[Docket No. 83-ANE-14-AD]

#### **Airworthiness Directives; Hartzell Propeller Inc. (formerly TRW Hartzell Propeller) Model HC-B3TN-2, HC-B3TN-3, HC-B3TN-5, HC-B4TN-3, HC-B4TN-5, HC-B4MN-5, and HC-B5MP-3 Turbopropellers**

**ACTION:** Notice of proposed rulemaking (NPRM).

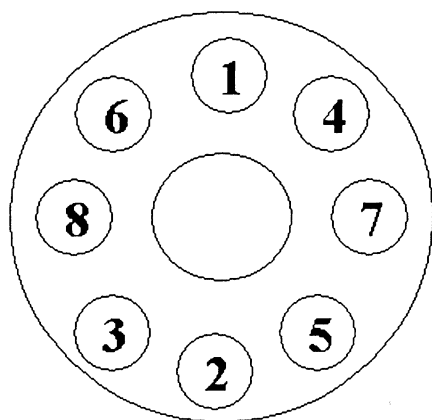
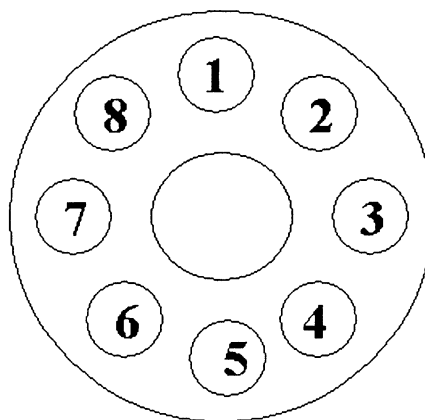
- (5) Torque all attaching bolts with a torque wrench and an appropriate adapter, to 40 ft.-lbs., and then to 80 ft.-lbs. Following sequence "A" (shown below). Final torque all attaching bolts using sequence "B" (shown below) to 100 to 105 ft.-lbs. Safety wire all attaching bolts in an FAA-approved manner.
